FAQ Number 16-0011 FAQ Revision 1

FAQ Title Cable Tray Ignition

Plant:	<u>Harris</u>	Date:	<u>June 2, 2016</u>
Contact:	<u></u>	Phone:	<u>(919) 546-4570</u>
	<u>Harold Stiles</u>	Email:	<u><a href="mailto:Harold.Stiles@Duke-Energy.com">Harold.Stiles@Duke-Energy.com</a></u>
	<u>Robert Cavedo</u>		<u><a href="mailto:Robert.Cavedo@ExelonCorp.com">Robert.Cavedo@ExelonCorp.com</a></u>
	<u>Francisco Joglar</u>		<u><a href="mailto:FJoglar@jensenhughes.com">FJoglar@jensenhughes.com</a></u>
	<u>Kyle Christiansen</u>		<u><a href="mailto:ChrisIK@Westinghouse.com">ChrisIK@Westinghouse.com</a></u>
	<u>Young Jo</u>		<u><a href="mailto:ygio@southernco.com">ygio@southernco.com</a></u>

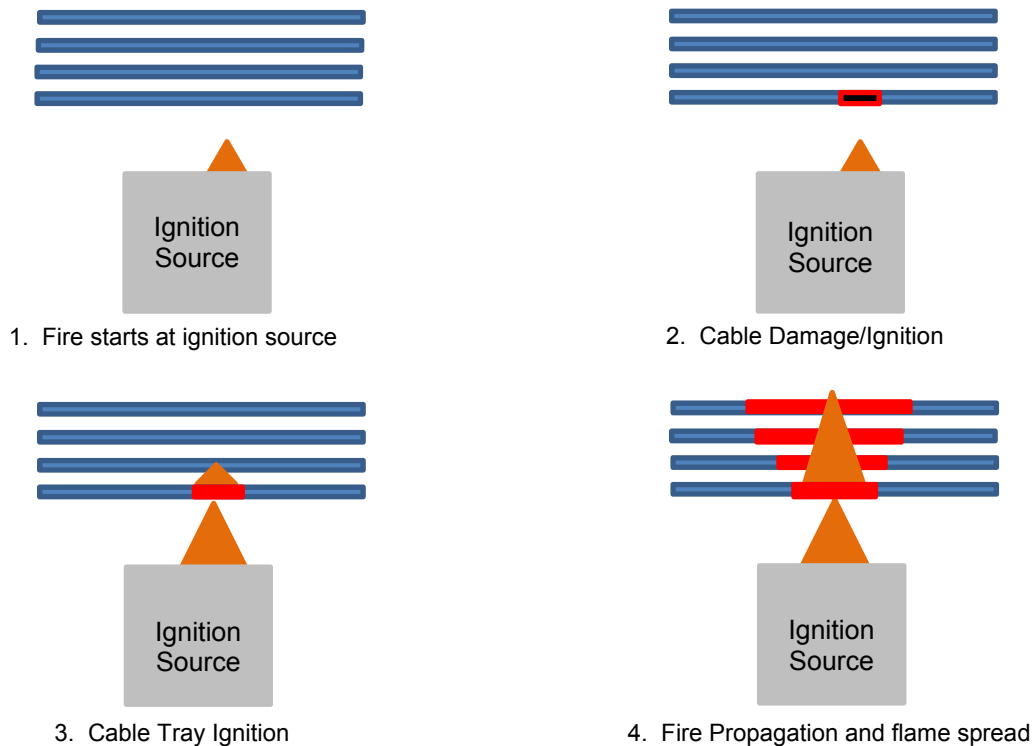
The following sequence provides a conceptual representation of the proposed scenario development for FPRA modeling purposes:

1. Ignition: Fire starts at ignition source generating a zone of influence affecting nearby cables in cable trays or conduits.
2. Cables in cable trays are damaged when exposed to thermal conditions exceeding the cable damage and ignition criteria listed in [Table 1Table 1Table 4](#). Localized ignition of cables can occur due to shorts; however, the exposures are insufficient to sustain a significant heat release rate (e.g. is a measurable fraction of the ignition source heat release rate). Assume cables are damaged by localized ignition regardless of their location within a cable tray/conduit arrangement if the thermal conditions at the location of the cable tray exceed the cable damage and ignition criteria listed in [Table 1Table 1Table 4](#).

3. If the analysis is applying the bulk cable/tray ignition criteria in [Table 1Table 1Table 4](#) (Method 2), or if the analysis is conservatively assuming bulk cable/tray ignition using the bounding thresholds listed in [Table 1Table 1Table 4](#) (Method 1), and the temperature or heat flux criteria for the applied method is exceeded, then, the resulting pyrolysis rates are sufficient that the entire length and width of the cable tray ignited begins to make a measurable contribution to the heat release rate of the ignition source. The length and width of the initial cable tray ignited used to calculate the heat release rate contribution should be determined following the guidance in Appendix R of NUREG/CR-6850 and/or NUREG/CR-7010 volumes 1 and 2.

4. Subsequent fire propagation and flame spread through a cable tray stack arrangement consistent with the guidance in NUREG/CR-7010, Vol 1.

The above sequence is recommended for growing fires only. The sequence is not applicable for high energy arcing fault fire scenarios. [Figure 1Figure 1Figure 1](#) provides a pictorial representation of the recommended sequence.
